APPLICATION NO.	FILING DATE	FIRST NAMED INVENTOR	ATTORNEY DOCKET NO.	CONFIRMATION NO.
10/710,897	08/11/2004	John M. Tiesler	04966 (LC 0163 PUS)	4896
36014	7590	07/06/2006	EXAMINER	
ARTZ & ARTZ, P.C. 28333 TELEGRAPH ROAD, SUITE 250 SOUTHFIELD, MI 48034			FIGUEROA, FELIX O	
			ART UNIT	PAPER NUMBER
			2833

Office Action Summary	Application No. 10/710,897	Applicant(s) TIESLER ET AL.	
	Examiner Felix O. Figueroa	Art Unit 2833

DETAILED ACTION

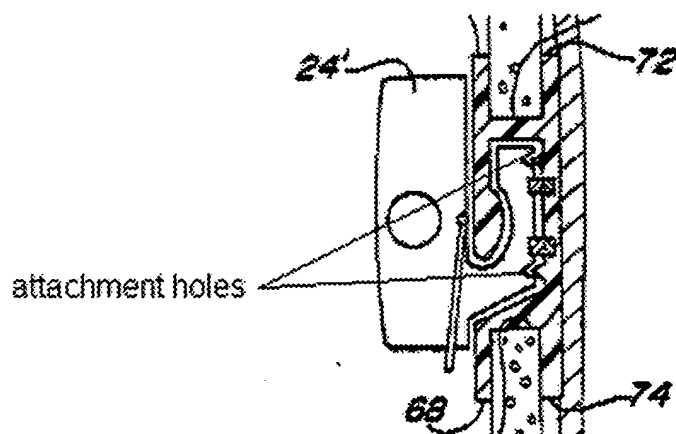
Dutta discloses vehicle overhead module powerstrip assembly comprising: at least one overhead attachment strip (18) configured to couple to a vehicle overhead structure; at least one electrically conductive strip (50) coupled to the at least one attachment strip; and a plurality of modular connector (at 54,56, see col. 2 lines 55-57), each comprising a plurality of electrical contacts having a plurality of attachment positions (Fig.1) along the at least one electrically conductive strip, the plurality of modular connector removable from the conductive strip (col.4 lines 28-29), positioned

interchangeable with each other, and configured to couple an overhead electronic module (24) to the at least one electrically conductive strip.

Regarding claim 14, Dutta discloses the at least one modular connector comprises at least one insulator separating the plurality of electrical contacts; and the insulator comprising a plurality of module attachment holes (see the following figure).
